21-094INF – 5055 UPPER METRO – MIXED-USE

Summary

21-094INF
Informal Review
Dwight McCabe - McCabe Companies
5055 Upper Metro Place

February 2022

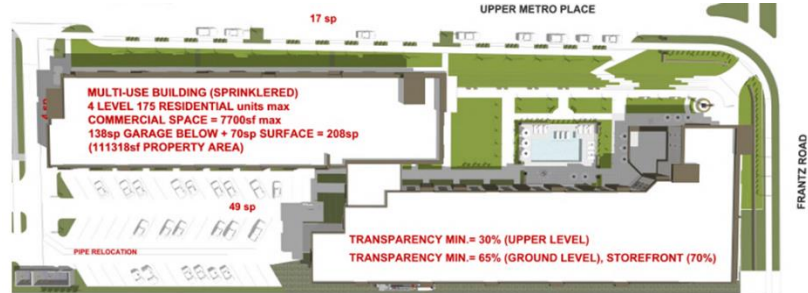
The 2.55-acre site is located southwest of the intersection of Upper Metro Place and Frantz Road, and is zoned BSD-C: Bridge Street District – Commercial. This district applies generally to existing retail centers and other low-rise commercial uses, including single use freestanding retail buildings, as listed in Table 153.059-A of the BSD Code. The applicant is seeking informal review and feedback on a revised proposal.

July 2021

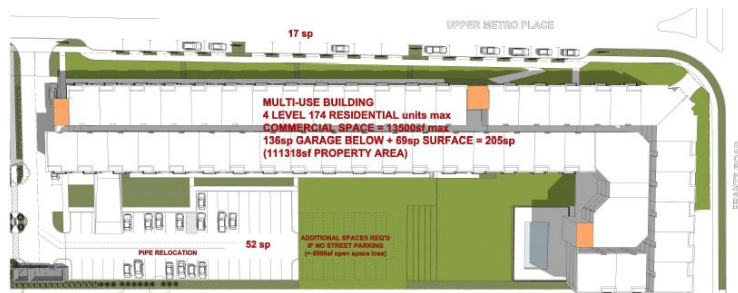
On July 8, 2021, the proposal was presented to the Planning and Zoning Commission (PZC) as an Informal application. The Planning and Zoning Commission's feedback focused on parking, open space and amenity spaces. Specifically, the Commission expressed concerns

for the massing of the building along Upper Metro Place, the lack of visibility of the open space and potentially the site lacking the space to accommodate all of the proposed uses. The Commission briefly discussed the on-street parking but noted more analysis would be necessary to formulate support for the parking.
